Ref: L22321/PAK/21-014

18 August 2021

**Re: Noise Amenity Review  
Amended Proposal  
Animal Keeping Facility (Kennels)  
2312 Steve Irwin Way, Landsborough**

**Plate 2: Acoustic Details – Project Drawings**

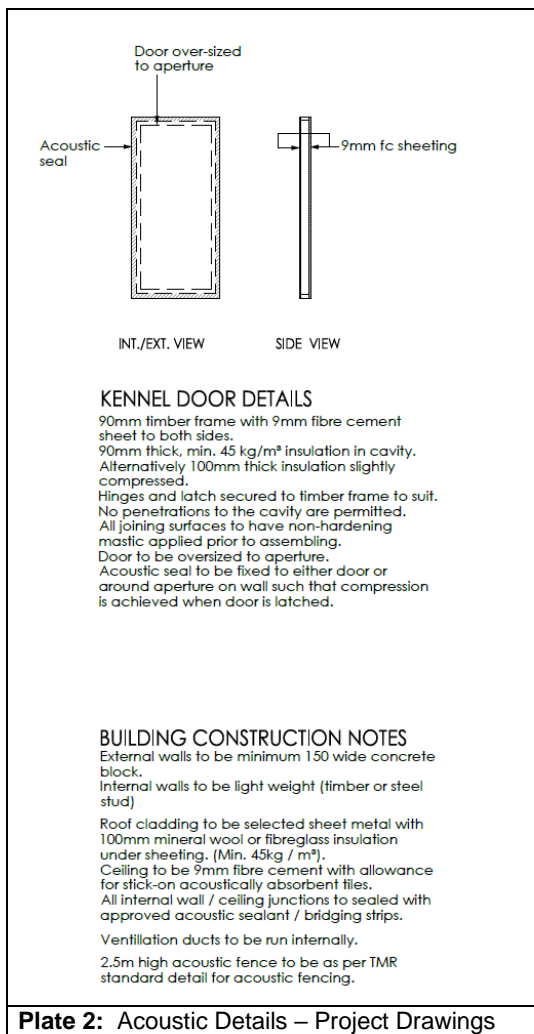
It is my opinion that the above proposed construction details are appropriate in providing acceptable noise containment of dogs enclosed in the kennels during the 6pm to 7am period. Further, the proposed acoustic barriers and acoustic absorptive elements provide containment of daytime noise of dogs outdoors which was not a feature of the original development proposal.

Plate xx: Proposed 1.2 metre high opaque screens between runs (Visual screening) – Project Design Drawings

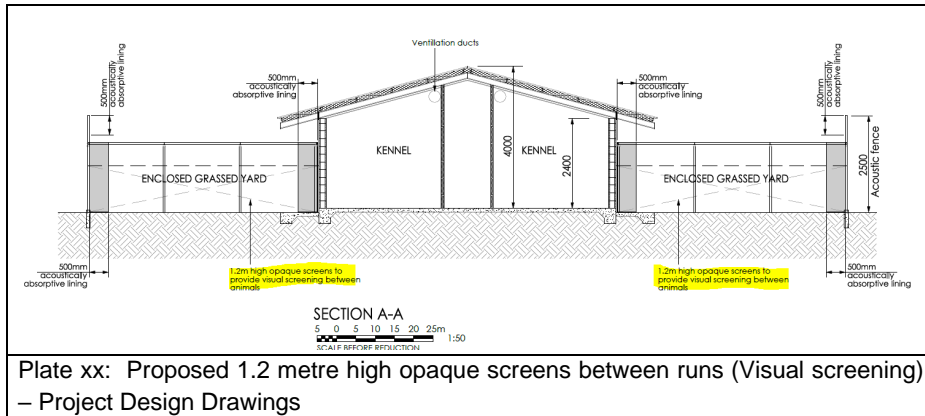
In addition it is noted that the project drawings also identify provision of 1.2 metre high opaque screens to form part of the dividing fences between outdoor runs to provide visual screening between different pens and reduce potential barking. These are considered a necessary inclusion into the design.
